11 SUB2011-00054

SCHOLTES SUBDIVISION, LOT 1 AND LOT 2 OF LOT 36

DETAIL SITE PLAN

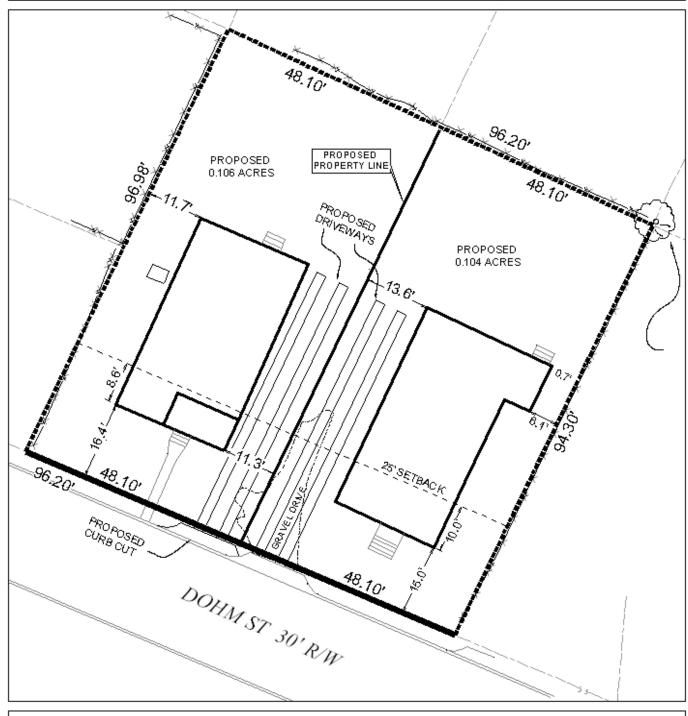
It should be noted that the plat does not label the proposed lots as "Lot 1" and "Lot 2". Therefore for the purpose of this report, the Western lot shall be referred to as "Lot 1".

The lot sizes are labeled on the preliminary plat, and it appears that both lots will not meet the minimum size required by Section V.D.2. of the Subdivision Regulations of 7,200 square feet. The proposed Lot 1 is 4,361 square feet, and Lot 2 is 4,566 square feet. It should also be noted that there are several other lots in the area that are also below the Subdivision Regulations minimum lot size requirement. If approved, this subdivision would require a waiver of Section V.D.2. of the Subdivision Regulations.

The 25-foot minimum building setback line, required in Section V.D.9. of the Subdivision Regulations, is shown for the subdivision, and should be shown along all frontages, if approved. It should be noted that the existing dwellings on both proposed lots are within the minimum front setbacks. Any future additions to the residences would not be allowed in the setback without a successful variance application to the Board of Zoning Adjustment.

Both of the proposed lots have 48.1' feet of frontage on Dohm Street. This would qualify both lots for reduced side yard setbacks of 6.9' at a minimum and 16' for a combined side yard setback according to Section 64-4.D.7 of the Zoning Ordinance. While both lots meet the combined side yard setback, it should be noted Lot 2 will have a side yard setback of 6.1' on the Eastern side.

It should be noted that there is currently an existing curb cut from Lot 2 onto Dohm Street, and if approved, Lot 1 should also be allowed one curb cut onto Dohm Street.

- 1) provision of a note on the Final Plat that no additions can be built within the 25' front building setback without a successful application to the Board of Zoning Adjustment;

- 2) labeling of "Lot 1" and "Lot 2";
- 3) depiction of the 25-foot minimum building setback line from Dohm Street, as required by Section V.D.9. of the Subdivision Regulations;

- 4) the labeling of each lot with its size in square feet, or placement of a table on the plat with the same information;
- 5) compliance with Engineering comments (Must comply with all storm water and flood control ordinances. Any increase in impervious area in excess of 4,000 square feet will require detention. Any work performed in the right of way will require a right of way permit.)

- 6) placement of a note on the Final Plat limiting both lots to one curb cut to Dohm Street, with the size, design, and location of all curb cuts to be approved by Mobile City Engineering and conform to AASHTO standards;
